Reroute HV Rapid Mate Ground Strap

Classification	Repair Bulletin	Section/Group	44 - High Voltage System	Country/Region	North America, Europe
Year	2012-2013	Model	Model S	Version	All

This Service Bulletin supersedes SB-14-44-006, dated 25-Aug-14. Each content change is marked by a vertical line in the left margin. Discard the previous version and replace it with this one.

✓ Correct
Figure 1

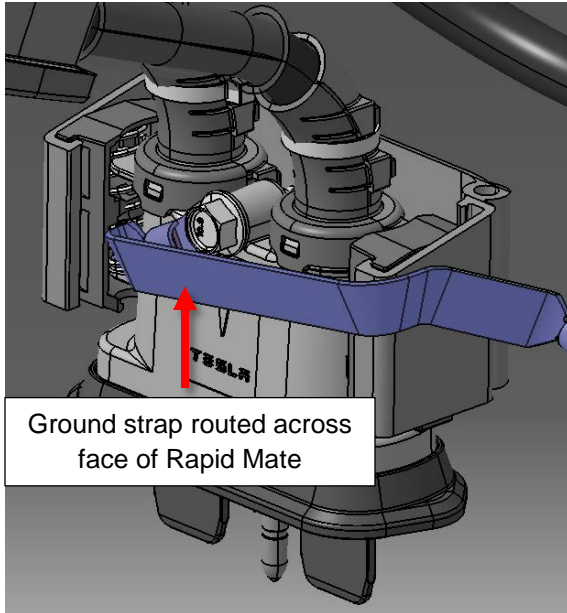
1. Inspect the HV Rapid Mate ground strap:
 - If the ground strap is routed across the face of the Rapid Mate connector (Figure 1), discontinue this procedure; no additional work is needed.
 - If the ground strap is routed between the HV cables (Figure 2), continue this procedure.

NOTE: The eyelet should extend from the bolt at approximately the 8 o'clock position (refer to Figure 1).

6. Retighten the bolt that secures the ground strap to the Rapid Mate (torque 9 Nm). Mark the fastener with a yellow paint pen.
7. Loop the ground strap over itself and across the face of the Rapid Mate (refer to Figure 1).

✗ Incorrect
Figure 2

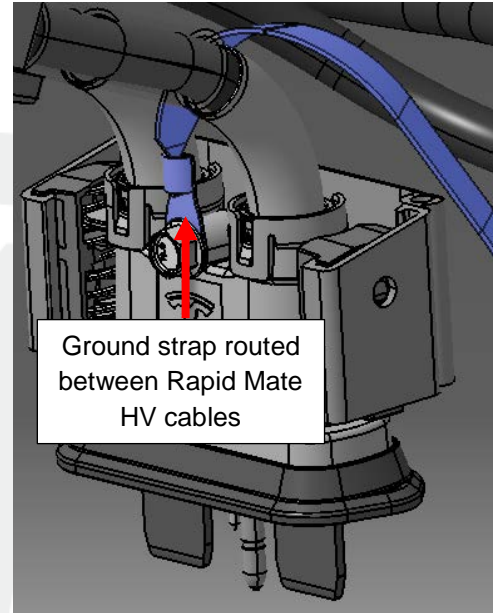
On some vehicles, the High Voltage (HV) Rapid Mate ground strap is routed between the HV cables. This prevents proper use of the Rapid Mate Seating Tool during reinstallation of the HV battery.

3. Pull the free end of the ground strap out from between the HV cables.
4. Loosen the bolt that secures the ground strap to the Rapid Mate, but do not fully release it.
5. Rotate the ground strap so that the eyelet points downward and to the left.

Figure 3

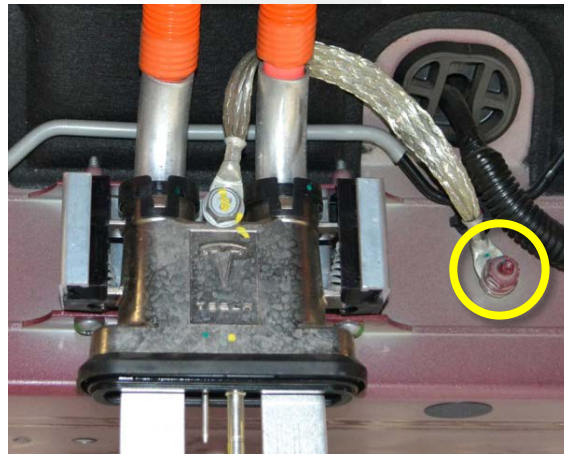
2. Release the nut that secures the ground strap to the body (Figure 3).
